Difference statement for NAYMAN SP130 and NAYMAN SP140 MAXX

Item	Difference	Picture	
1	主板差异 Motherboard Differences	Model: NAYMAN SP130	Model(s): NAYMAN SP140 MAXX

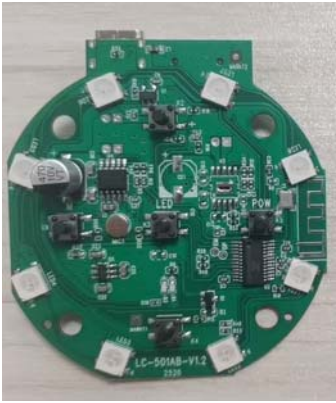
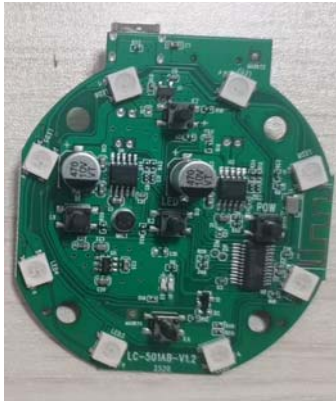
1.功放 IC: MIX8911 多一颗 2.电解电容: 470U/10V 多一颗, 3.贴片电容: C4,C6,C7,C12,C19,C13,分别多一颗。 4.贴片电阻: R15,R34 分别多一颗。 5.2P 针座: 多一个 2P/2.0 针座。 1. Amplifier IC: One more MIX8911 2. Electrolytic capacitor: one more 470U/10V, 3. Surface mount capacitors: C4, C6, C7, C12, C19, C13, one more each. 4. Surface mount resistors: one more R15 and one more R34. 5.2P needle holder: an additional 2P/2.0 needle holder.

NAYMAN SP140 MAXX AND NAYMAN SP130 have the same construction and PCB. Some components are NC in the PCB for NAYMAN SP130. Please refer to the above form for detail.

Importantly, NAYMAN SP140 MAXX AND NAYMAN SP130 have RF part circuit and component are same. And aslo, RF performance are same
